## **[NOTICE] Terminal Plating Change**

### **1. Change Item : Terminal plating (Sn-Bi to Pure-Sn)**

# Engineering Change Notice of Pure-Sn plating for QFP

Package : QFP

Solder ability1 Steam aging	Solder ability2 High temp storage
Photo after solder dipping

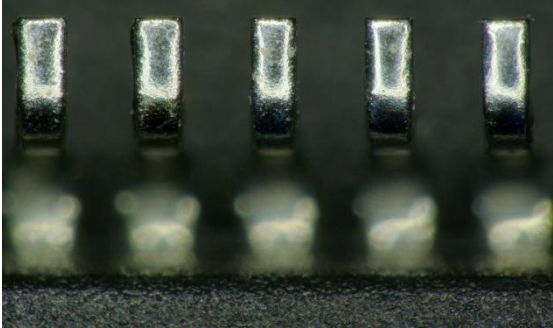
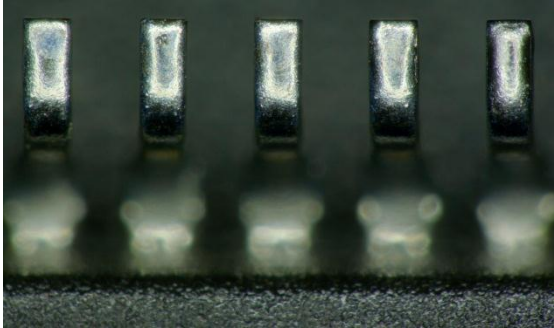
## ■ Solder ability1

Steam aging : 4hrs  
Flux dipping time : 5~10sec  
Solder temp. : 245°C  
Solder dipping time : 5sec

## ■ Solder ability2

High temp. storage : 150°C 16hrs  
Flux dipping time : 5~10sec  
Solder temp. : 245°C  
Solder dipping time : 5sec

Pass. All terminal solder wets rate more than 95%

<Representative photo after 1000 cycle >

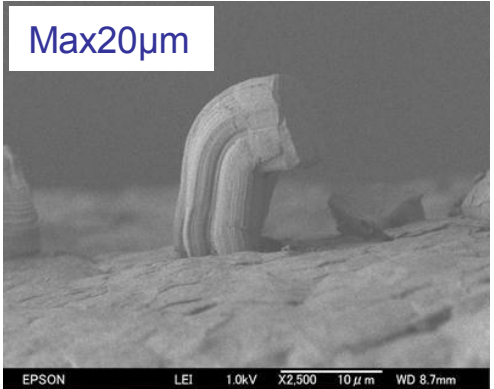
- Sample : P-LQFP048-0707-0.50(QFP12-48Pin) N=10
- Board spec.
  - Dimension : 100mm × 100mm t = 1.6mm
  - Material : FR-4
  - Layer count : 1 layer( One side board )
  - Cu layer : 35μm
  - Surface processing : Water-soluble pre-flux processing
- Solder paste : Sn-3.0Ag-0.5Cu
- Test condition : -40°C ⇔ 125°C (each 30 minute)
- Judgment criteria : A conduction part being left in the section part by section observation
- Test result : Pass. Because a conduction part is left in the section part after 1000cycle
